18-20 Elsworthy Road

Green Roof Proposal

Planning Reference: 2014/5413/P & 2016/2041/P

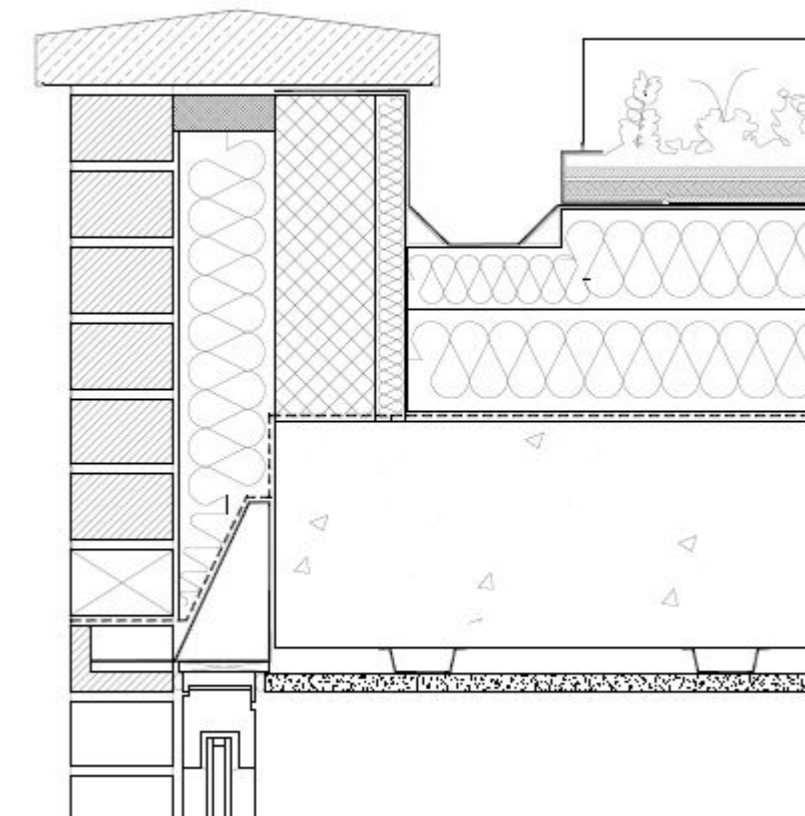
The approved drawing 18-20ELS - 417, shows sedum roof to the full extent of the roof at first floor level, totalling 42m². The approved details show a 150mm perimeter to the edge of the sedum roof.

With the 500mm gravel margins incorporated as shown on drawing (03)42, the proposed green roof will remain on the rear extensions, and will be omitted to the roof areas along Elsworth Rise and against no.16. This results in a total of 8m² sedum blanket at first floor level

New green roof areas will be added to the top of the external bin stores at the front gardens in order to retain as much green roof area as possible. This gives a total sedum blanket area of 14m²

Figure 5: Green roofs: vegetation-free zone: warm roof (elevation)

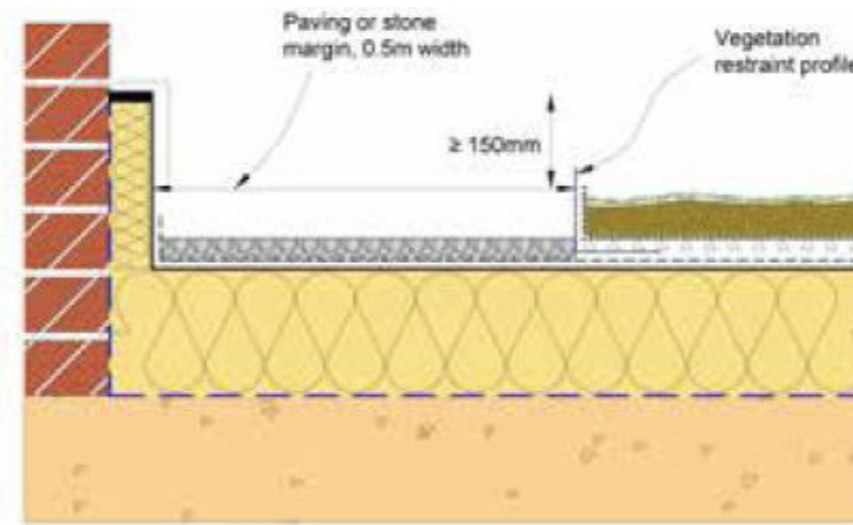
The amendment addresses a conflict between the approved planning drawings and the requirement under the developer's building warranty (Premier Guarantee) to provide a "vegetation-free zone of minimum 0.5m width at all perimeters, abutments and openings." (Figure 5 from Premier Guarantee Technical Manual)

1. 0.5m zone around openings, along abutments and at perimeters.
2. Vegetation restraint profile should be secured with ballast as necessary. Additional restraint will be required on sloping roofs to stop creep of the vegetation zone.
3. Protection of waterproof membrane should be extended under ballast zone.
4. Paving or stone should not simply be added to the growing medium at the perimeter as this (a) may reduce the available height of upstands and (b) will not stop plant growing in the zone.
